**Re: Pensacola Hydroelectric Project, FERC Project No. 1494-438  
Response to Comments on Updated Study Report**

RESPONSE TO COMMENTS  
ON  
UPDATED STUDY REPORT

Figure 6. Inflow hydrographs for the 100-year inflow event.

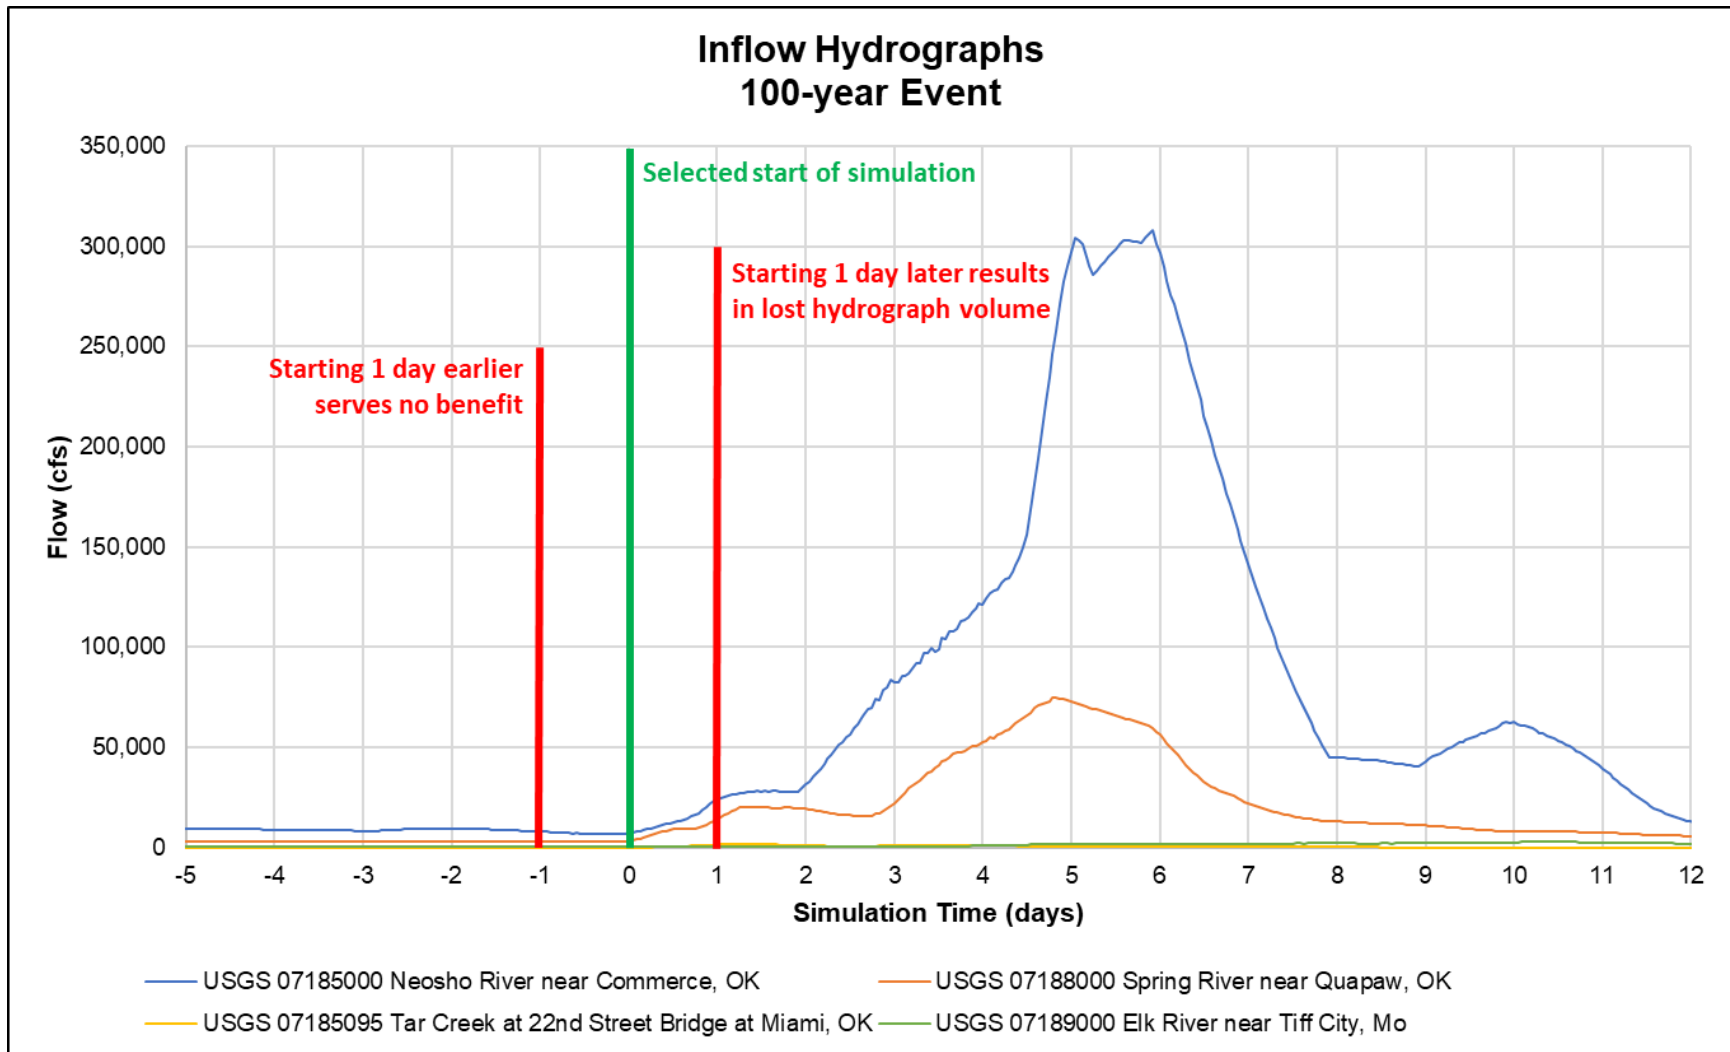
whether the hydrographs (figures C.7-C.12) are converging toward the reservoir rule curve that was in place at the time of the event, and, if so, whether this convergence is related to the stage matching discussed in section 5.4.3, *Flood Routing Model Stage Matching*. Further, please clarify whether this constraint also applies for the 100-year inflow event, which has no specified date from which to derive a rule curve elevation. Finally, please explain whether the start of the simulations could be adjusted so that the prescribed starting elevation for a given inflow event is still in effect when the storm flows arrive.<sup>269</sup>

Note that the simulations themselves extend past the last date displayed in the figures. The purpose of the figures is to show the start date of the simulation, the inflow event hydrographs, and how GRDA selected the most appropriate starting date.
